ACKNOWLEDGMENT OF ADDENDUM #3

We do hereby acknowledge the information and/or changes described in
Addendum #3 to Request for Proposals 2025-006 Pinebrooke 5 Renovation Phase 1

Addendum No:	#1	Issue Date:	10/6/25
Project:	HCSO Training Academy Phase 1	To Drawings + Specifications dated	8/6/2025
Prepared By:	Harvard Jolly PBK 5201 W. Kennedy Blvd. Suite 515 Tampa, FL 33609		
PBK Project No:	23106

TRAINING ACADEMY - PHASE 1

T-200

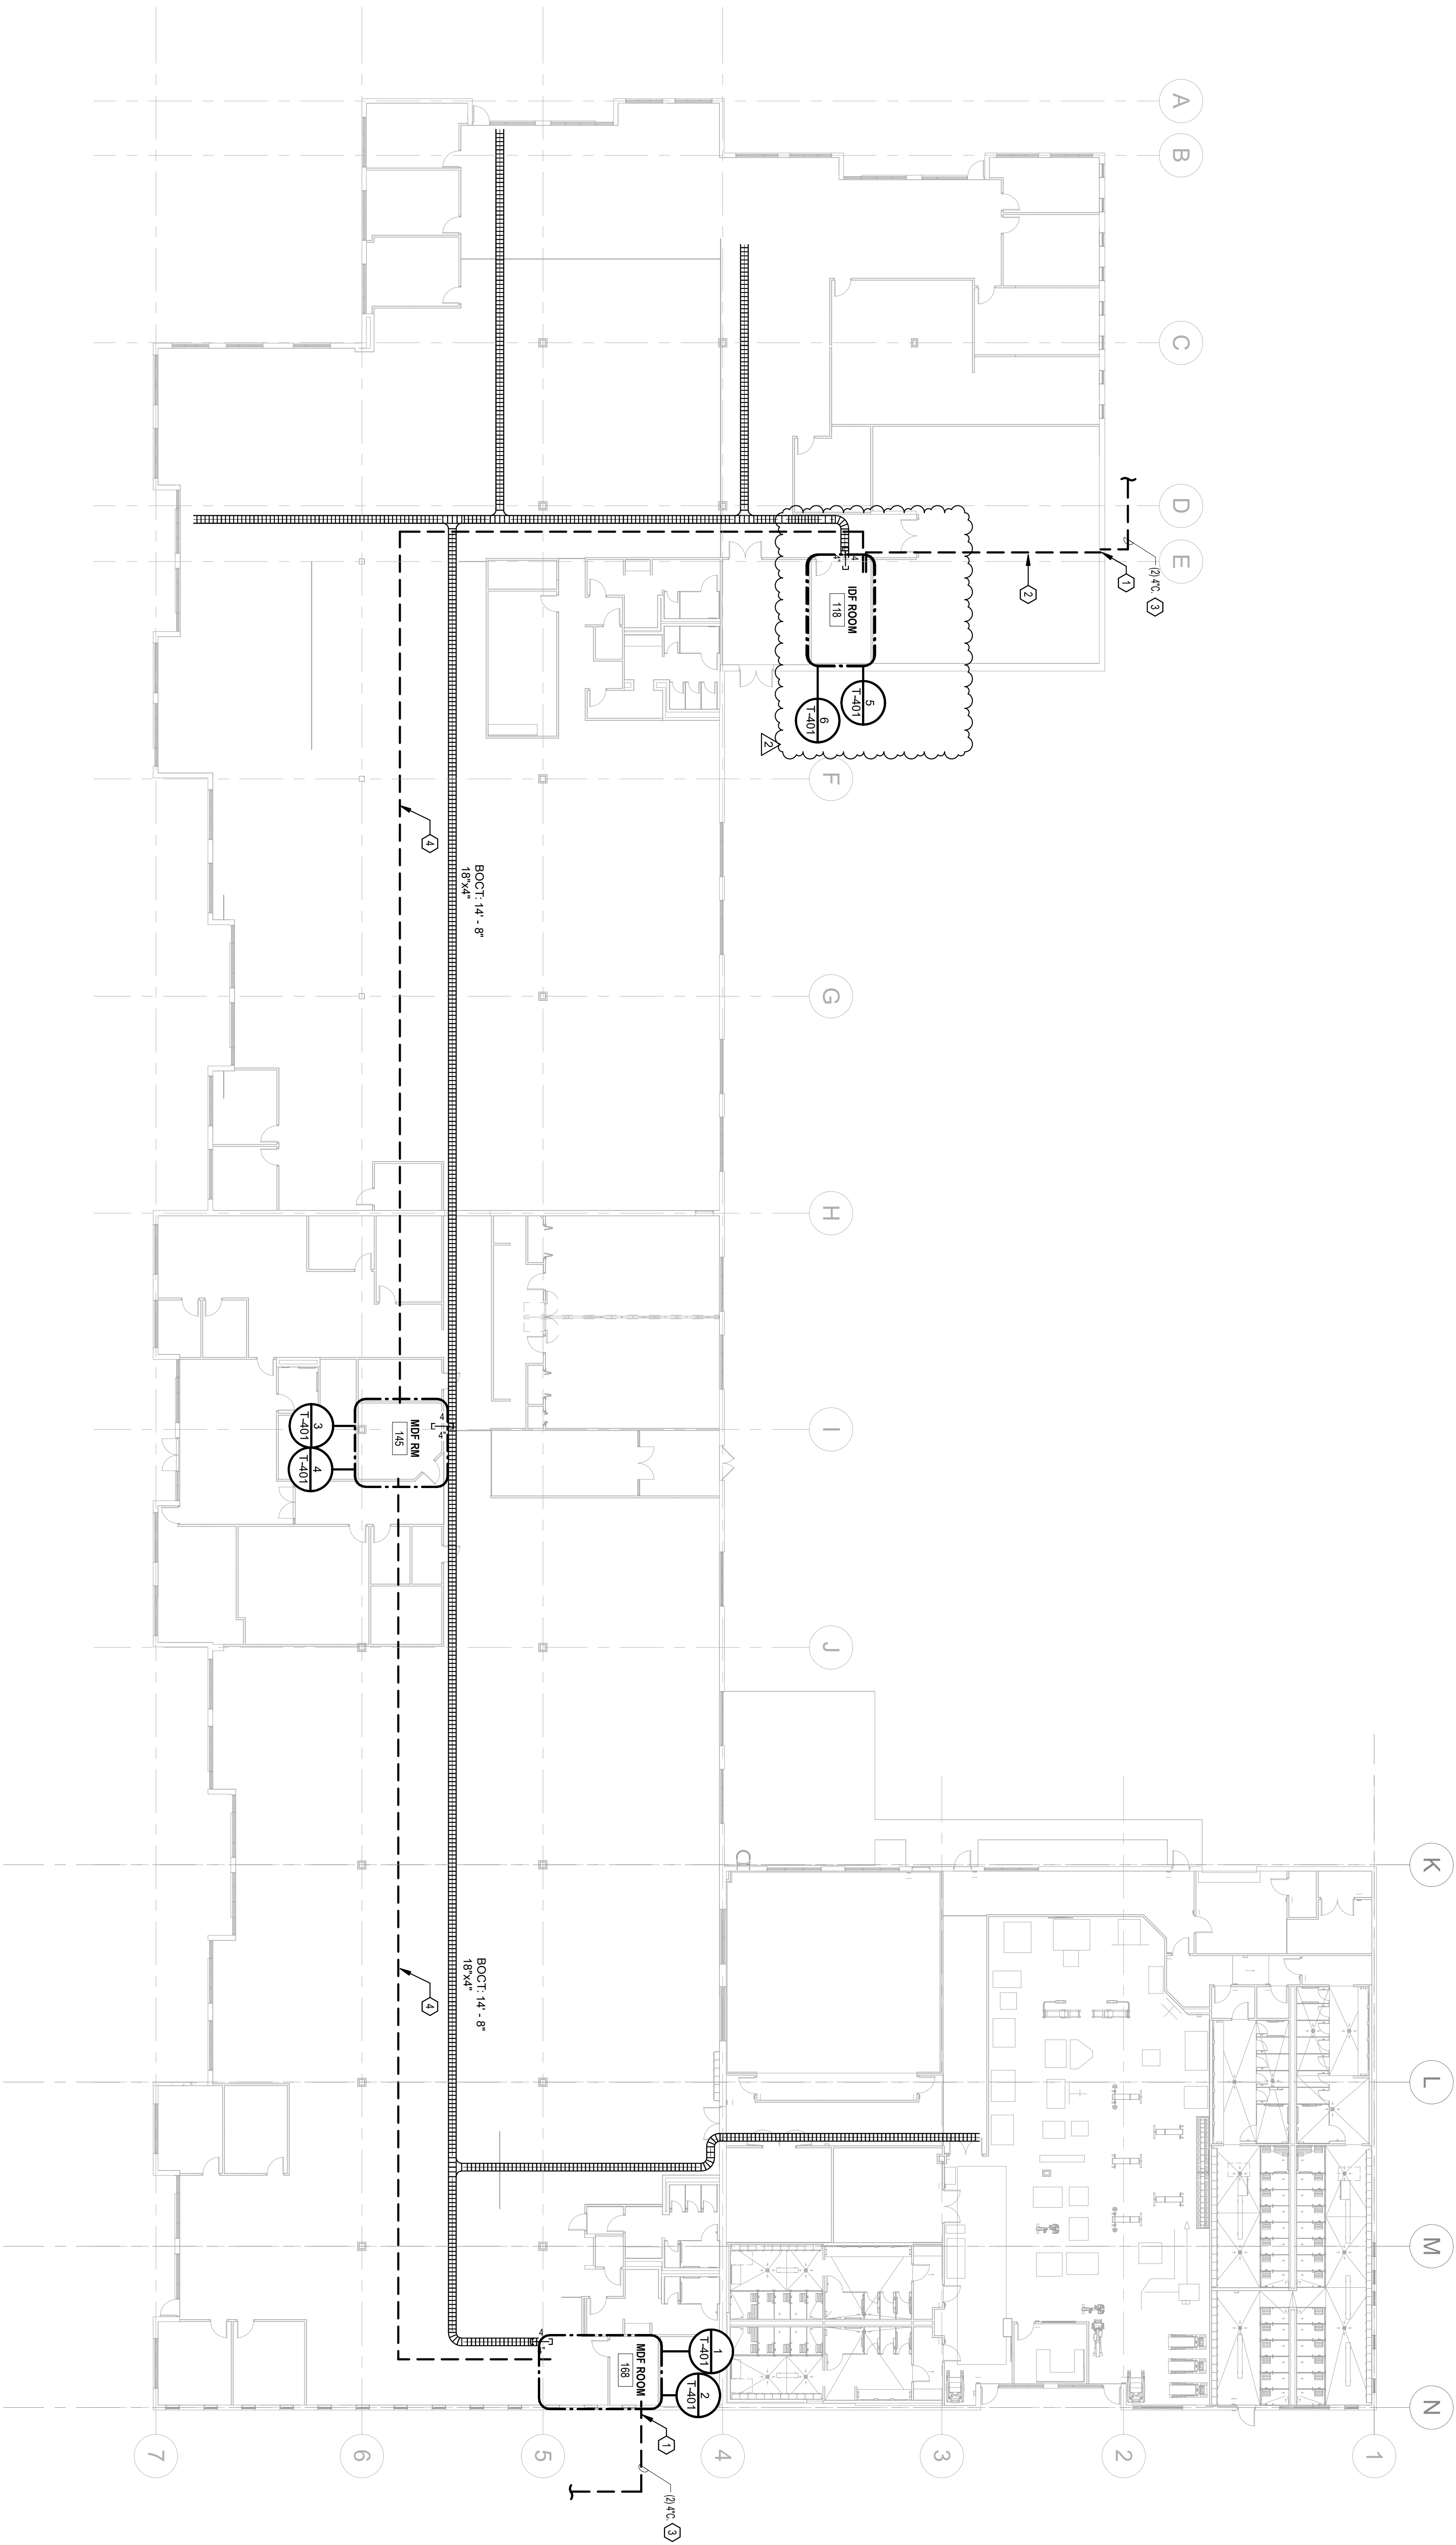
E-401: Revised IDF Room 118
E-501: Revised one line diagram
E-601: Revised panels L1A-1 and LUC
T-200: Revised IDF Room 118
T-401: Revised IDF Room 118

G-081

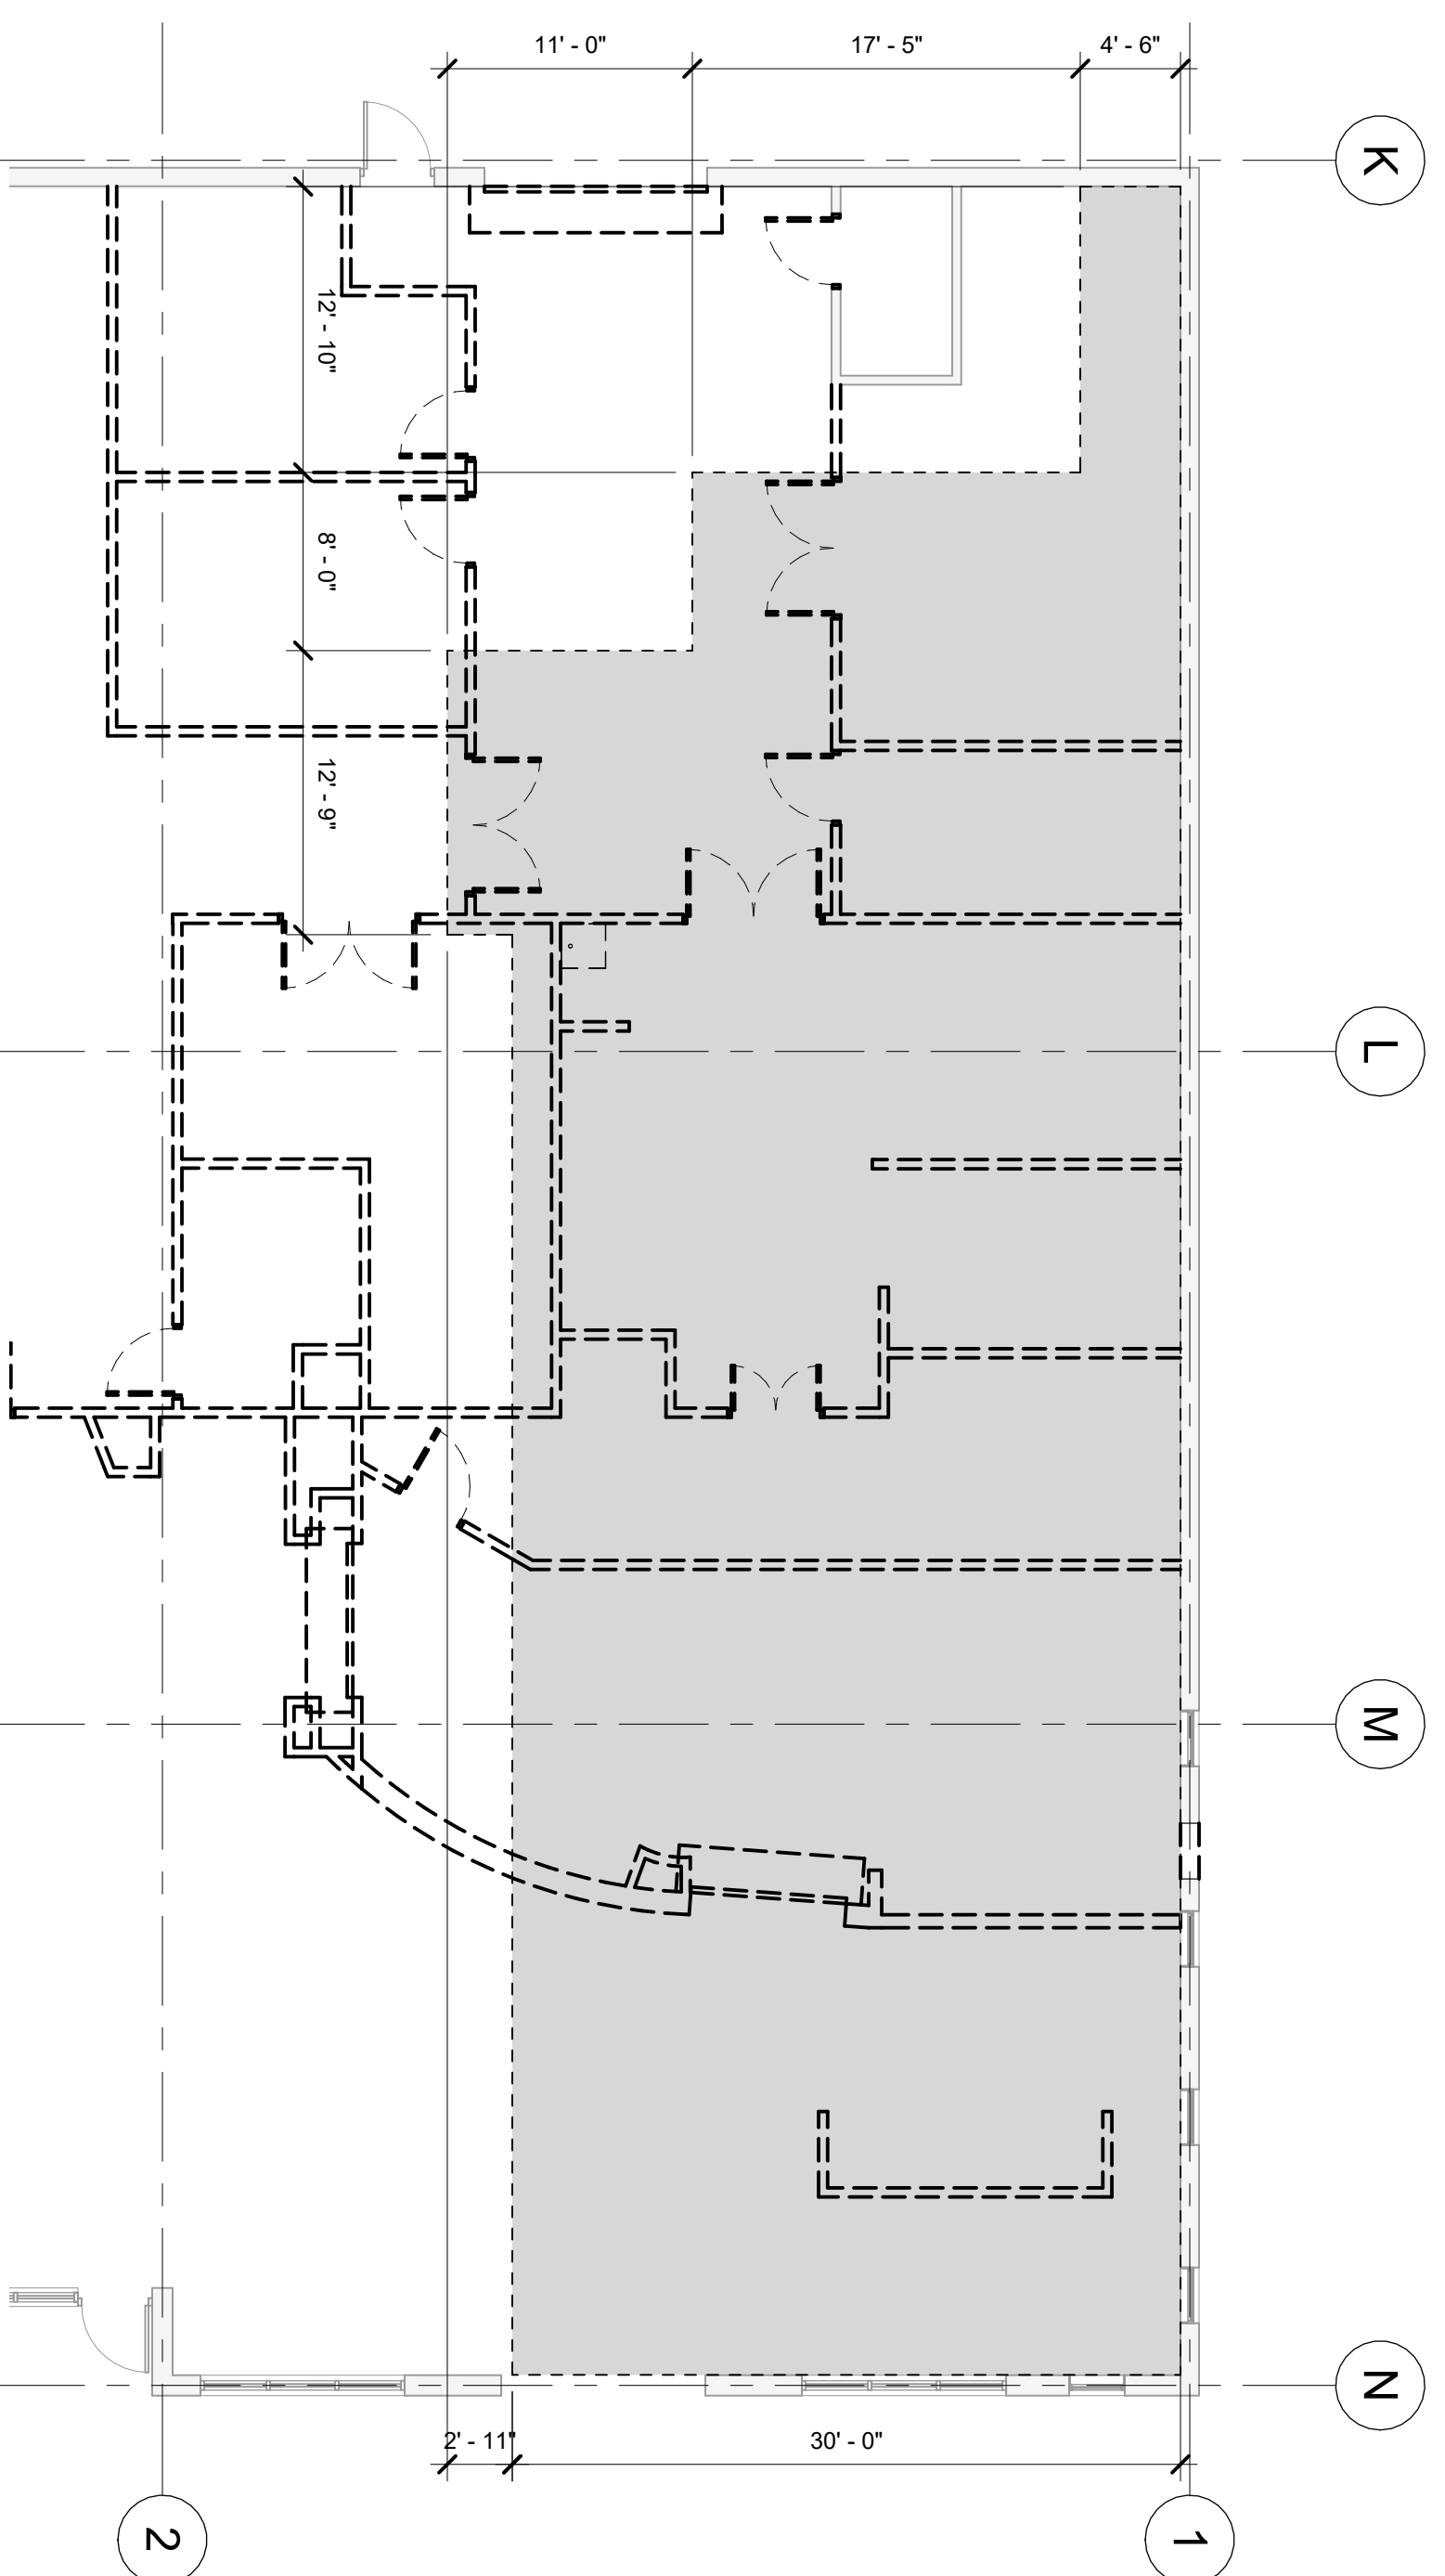
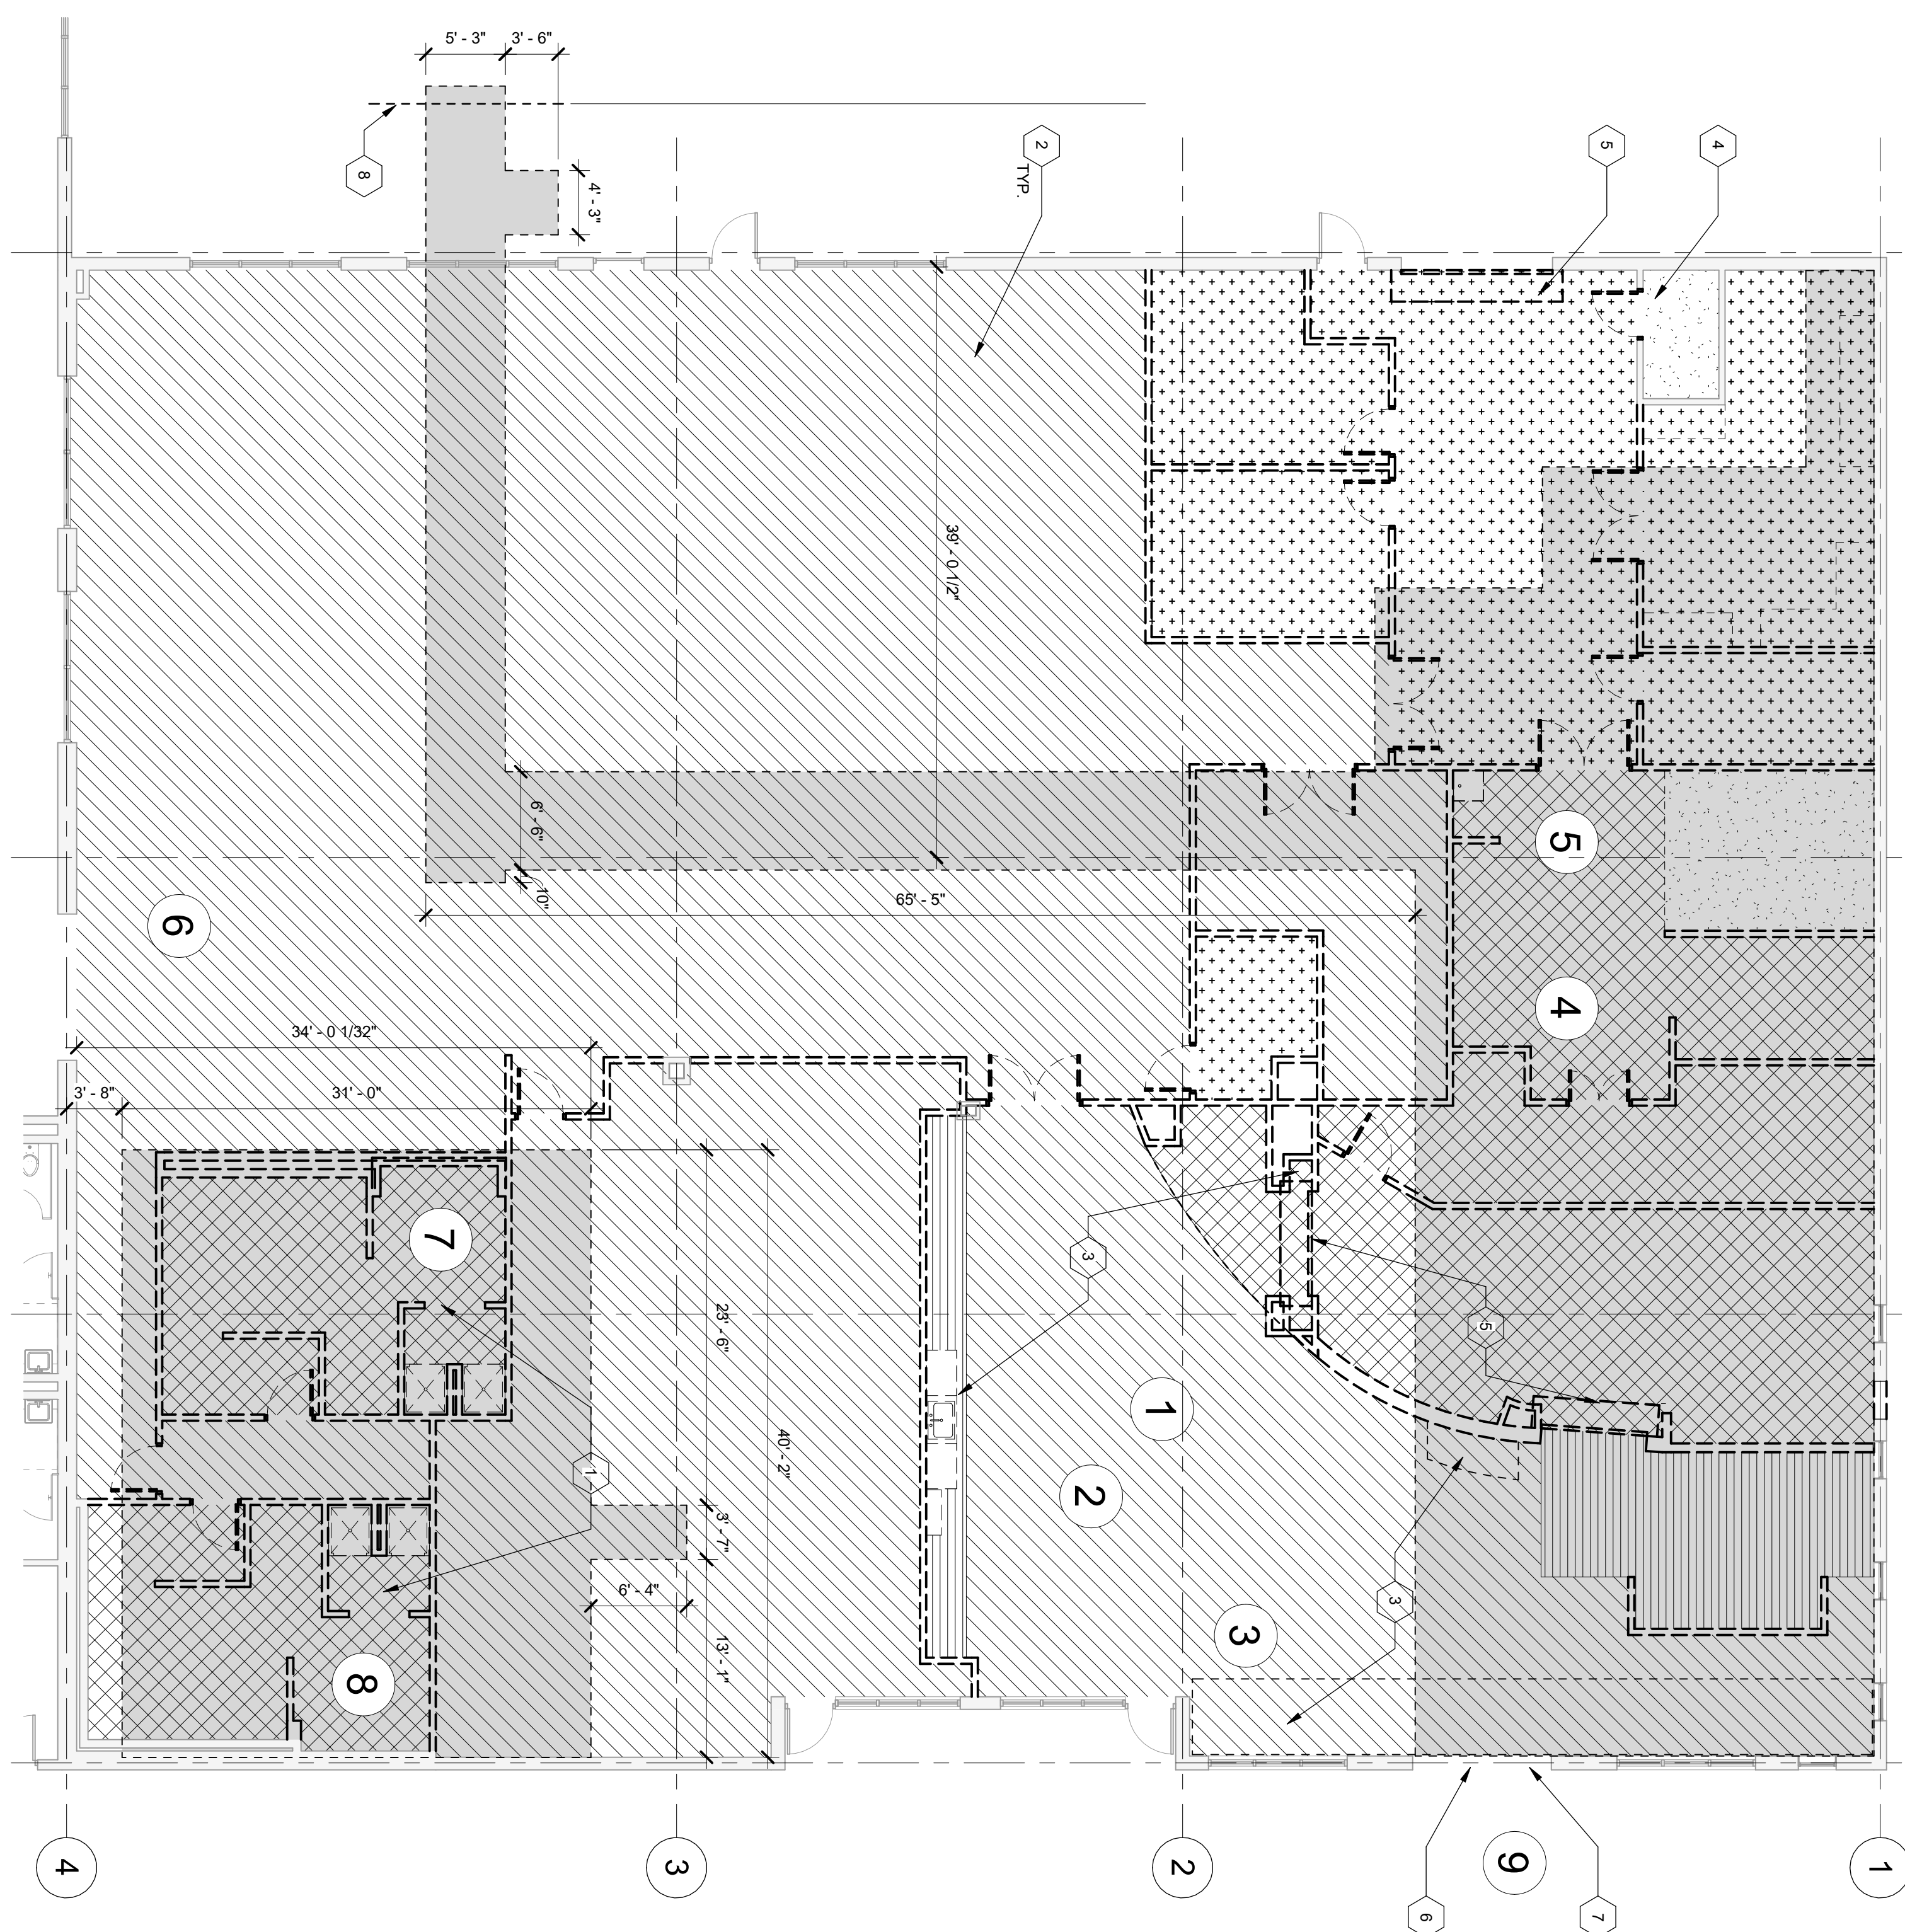
G-081: Narrative and graphic depiction of Add Alternates 2 and 3.
